**EB-2023-0343 East Gwillimbury Community Expansion Project Leave to Construct
Pollution Probe Interrogatories to the Applicant**

**Enbridge Gas Inc.
East Gwillimbury Expansion Project
Leave to Construct**

POLLUTION PROBE INTERROGATORIES

Figure 1: Energy Savings (percentage) for a ccASHP compared to natural gas, oil and baseboard electric.

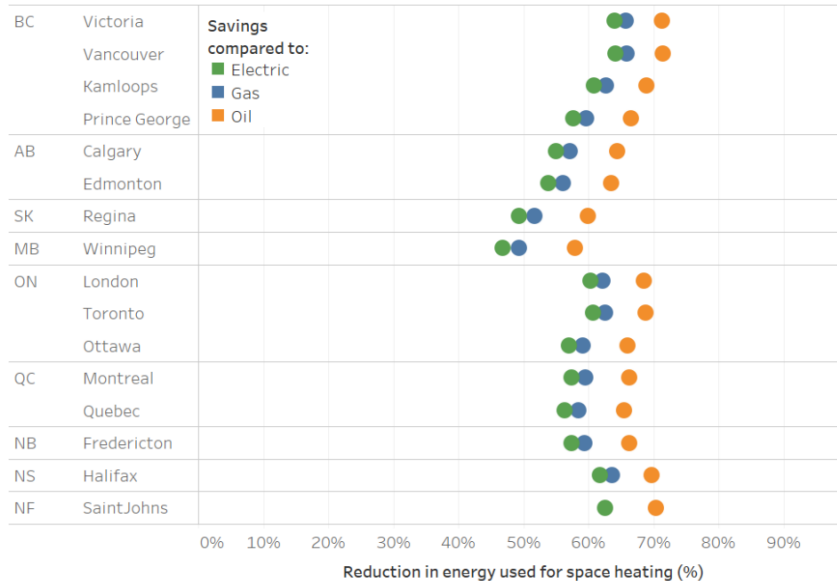
The CanmetENERGY cold-climate air source heat pump (ccASHP) Report filed by Enbridge indicates in Figure 1 (above), that for Ontario jurisdictions a ccASHP is approximately 50% to 70% more efficient than natural gas, oil or resistance (i.e. baseboard) electric.

- a) Please indicate whether this best available information for ccASHPs was shared with potential customers as part of the information related to heat pumps. If it was, please provide a copy of the information/materials provided to consumers.
- b) This information was provided by Enbridge in 2023 based on a 2022 Study. If Enbridge has a more recent/relevant study/information that provides a different savings rate for ccASHPs vs. natural gas, oil or electric resistance heating, please provide a copy.

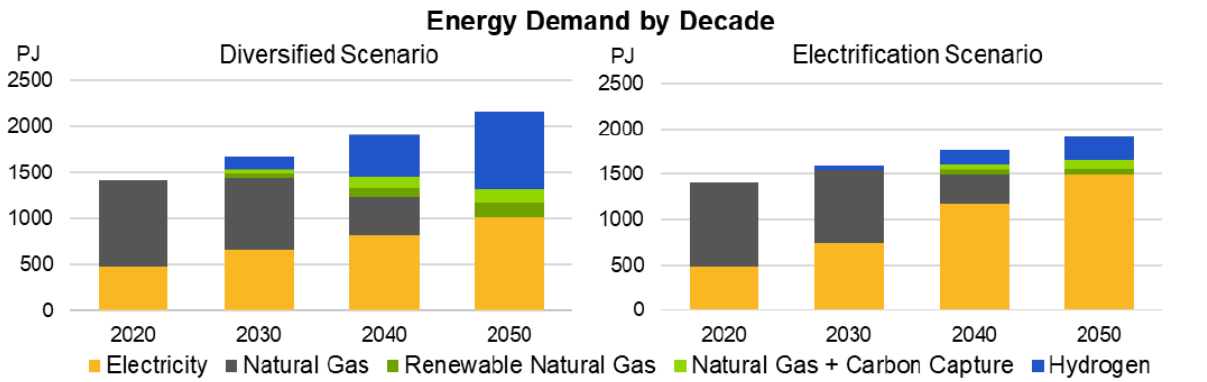
Has Enbridge conducted a risk assessment on the probability that the proposed pipeline will become a stranded asset before being fully depreciated? If yes, please provide a copy of the assessment and all related materials. If no, what evidence exists to support that the pipeline will remain used and useful for the full amortization period.
